UNITED STATES PATENT AND TRADEMARK OFFICE

10/576,258

Office Action Summary	Application No. 10/576,258	Applicant(s) MASAMURA ET AL.	
	Examiner MARINA TIETJEN	Art Unit 4177

DETAILED ACTION

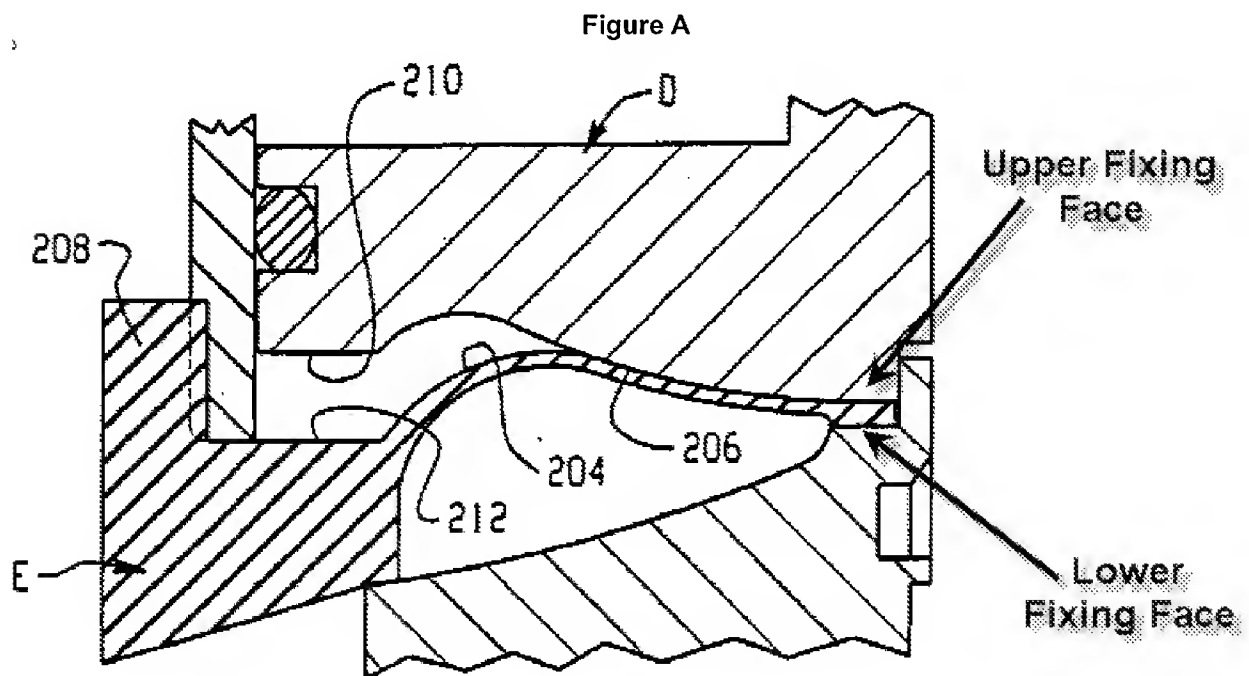
Regarding Claim 2, Brown et al. discloses the diaphragm valve element E (Fig. 9c) in which the diaphragm part 16 (Fig. 2b) having a thin wall (col. 4, lines 33-34, 39-42) and the fixed part 28 (Fig. 2b) having a thick wall are formed so that respective upper surfaces are flush with each other (Fig. 9c), and the fixed part 28 is held between an a lower fixing face (see Fig. A below) and an upper fixing face (see Fig. A below) which extends to the diaphragm part 16.

Regarding Claim 3, Brown et al. discloses a guide face 202 (Fig. 9b) having a slope contiguous from the upper fixing face (see Fig. A above) above the diaphragm part 16 (Fig. 2b) so that the diaphragm part 16 comes into contact with the guide face 202 when the diaphragm valve element E (Fig. 9b) is separated from the valve seat H (Fig. 1a).
